State of Ohio Environmental Protection Agency

Re: Jackson County
Wellston WWTP
Ohio EPA Permit No. 0PC00013*KD
NPDES Permit No. OH0023507
Notice of Violation
Correspondence (PWW)

Unsanitary/nuisance condition near culvert under McGhee Lane

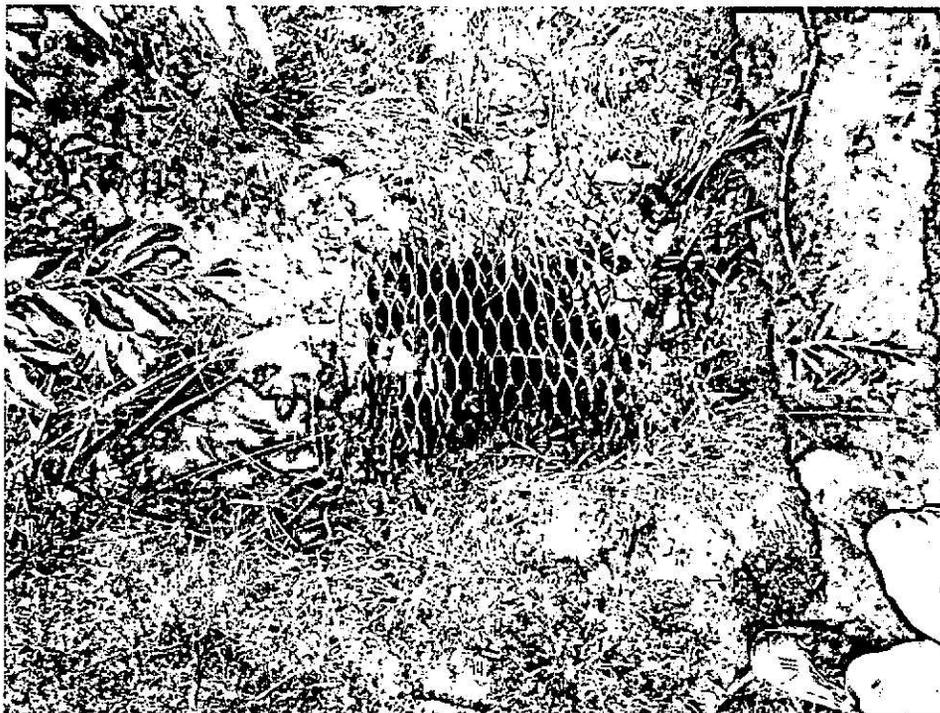
Our office has been informed of complaints of septic and/or nuisance conditions along McGhee Lane contributing to an unnamed tributary of Meadow Run. I met with Jackson County Health Department on June 25 upon the initial calls from local residents to the Health Department. There was some recent activity of service line repairs noted during that site visit. I had noted that a house had burnt down at 122 Montgomery Meadows when I revisited the site on July 23, 2009. The conditions have not been improved in the last ~30 days. The following photographs visually attest to the condition. There seems to be a sanitary sewer tied to a storm sewer in front of the residence at 240 McGhee Lane.

At the daylight side of the pipe a couple houses up McGhee Lane, there was no observable unsanitary/nuisance conditions and also no flow. The flow at this source was similar in flow rate to the flow surfacing at the culvert under McGhee Lane. The collection systems of sanitary and storm appear to be crossed. Please describe the City's actions to date and future actions to remedy the situation. I would advise taking Fecal Coliform samples of the flow if it is believed that the flow is not sanitary wastewater. Regardless, the discharge is an unauthorized discharge of pollutants to Waters of the State. The source of the nuisance/unsanitary water needs to be segregated from storm waters perhaps by tying into sanitary sewers.

Please inform this office in writing within 7 calendar days of the status of correcting for the nuisance/unsanitary condition. If you have any questions, please feel free to contact me at (740) 380-5272.
